AP - 121

From: Chavez, Carl J, EMNRD
Sent: Friday, November 22, 2019 9:45 AM
To: 'Moore, John'; 'Moore, Brian'
Cc: 'McCartney, Gregory J.'; Griswold, Jim, EMNRD; Wade, Gabriel, EMNRD
Subject: RE: Wingate Geoprobe Investigation WMW-2 Benzene Exceedance (AP-121) Work Plan

The New Mexico Oil Conservation Division (OCD) has reviewed the Marathon Memorandum (see attachment) dated November 1, 2019 related to the above subject topic.

To: Carl Chavez, Oil Conservation Division (OCD)
John Moore, Marathon Petroleum Corporation
From: (Marathon)
cc: Greg McCartney, Marathon; Heidi Jones, Trihydro
Date: November 1, 2019
Re: Wingate Facility – WMW-2 Benzene Exceedance

Figure 1
Proposed borehole locations

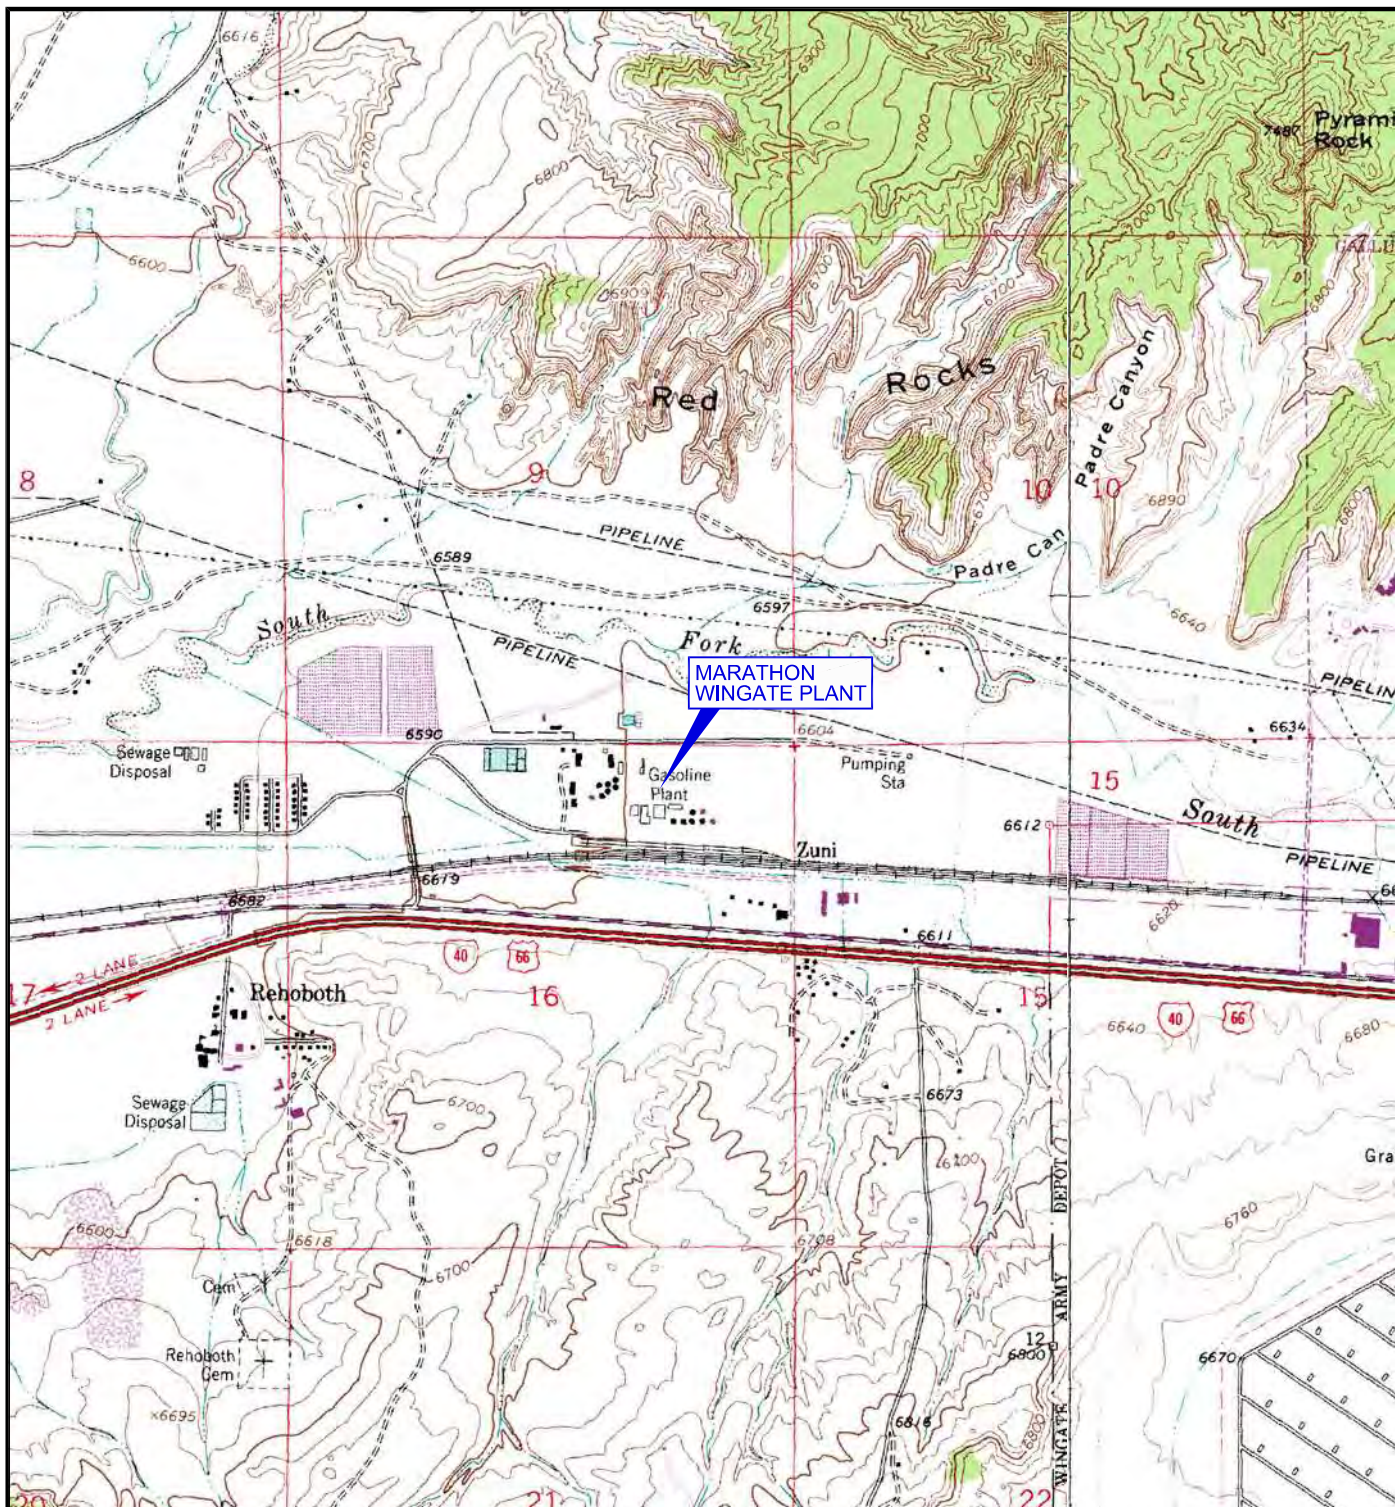
- 1) The map with proposed BHs does not have a scale; however, all BHs appear to be within Marathon Property.
- 2) Marathon mentions WMW-7 was installed into an artesian saturated sand zone below clay with head indicative of artesian condition. There appears to be a **shallow water table** aquifer or perched aquifer present at the facility. Perhaps the water table pinches out in the vicinity of WMW-7.
- 3) WMW-2 appears to be at or near the benzene source area.
- 4) No soil sampling is proposed.
- 5) All of the proposed BHs appear to be on Marathon Property.
